## MEETING MINUTES

**MEETING NAME** Design Development Review **MEETING LOCATION** Virtual

**PROJECT NAME** Knoxville Public Library Park

**FEH PROJECT NUMBER** 2023220

**LIBRARY GARDEN PARK**

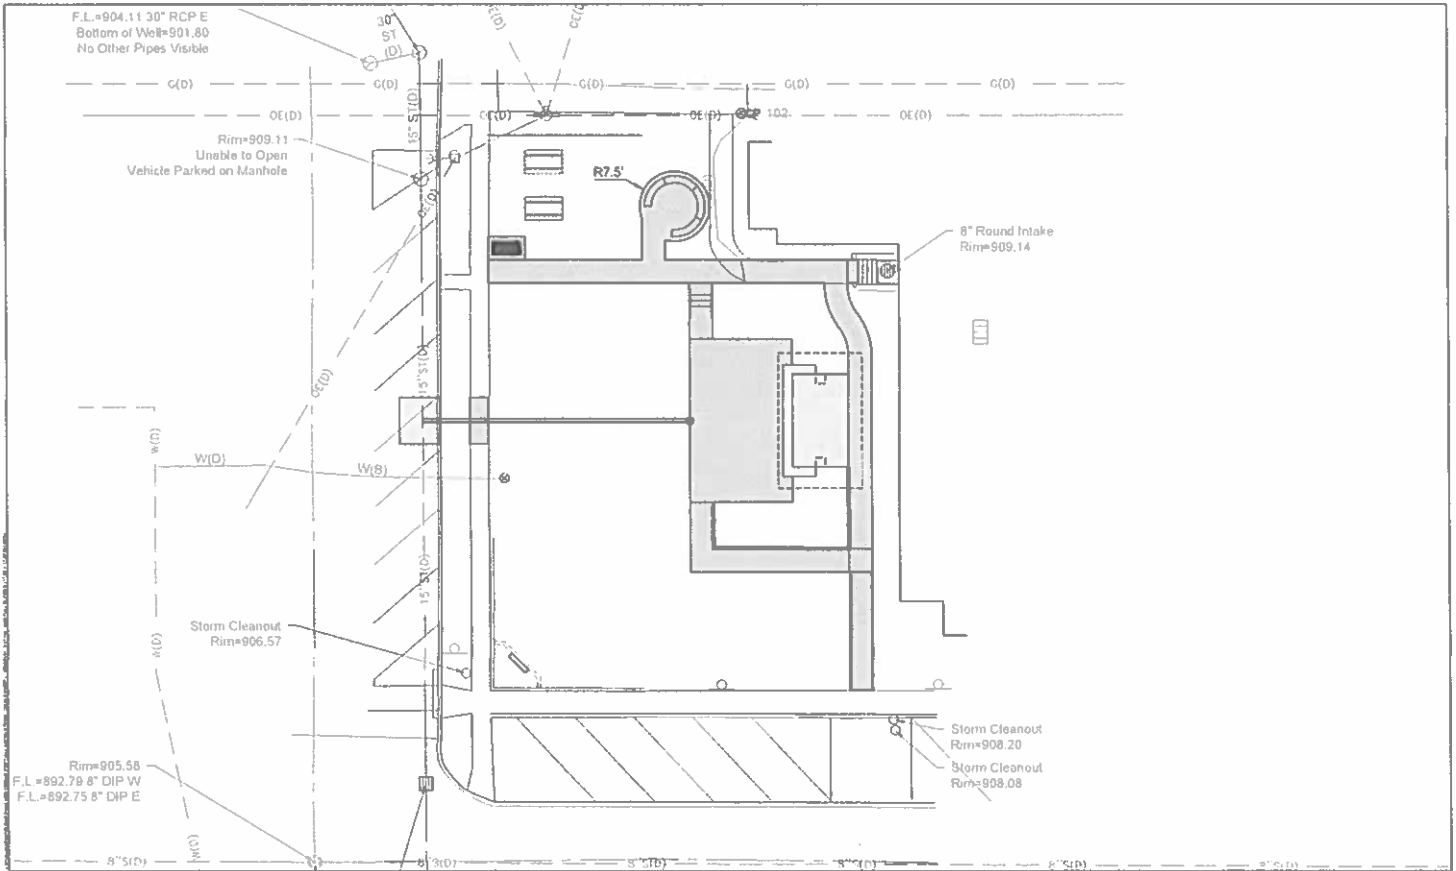
- During the meeting held at 3:30pm, the revised park design was discussed, with the following items noted:
  1. Reduce stage dimensions to 12'x16'.
  2. Butterfly roof structure design was well received.

3. Area South of stage to incorporate decorative stone to help with stormwater cascading from butterfly roof.
  4. Remove retaining walls.
    - a. Stairs have been moved to the Northwest corner of the plaza.

- b. The sidewalk path Northeast of the stage has been adjusted.
    - c. The distance between the North sidewalk and North edge of the plaza has been increased.

- d. Items a-c above eliminate steep grade changes in short distances, which allows a preferred grade slope of 4:1, and removal of the retaining walls.

5. Plaza size and location were well received.
  6. Sidewalks were approved as shown.
  7. Owner verified to move forward with showing defined space for flower beds with hard edge and mulch being provided and installed by contractor on Western edge of Park. Owner to provide and install flowers.

8. Large concrete steps in front and wrapping the North and South sides of stage were well received.
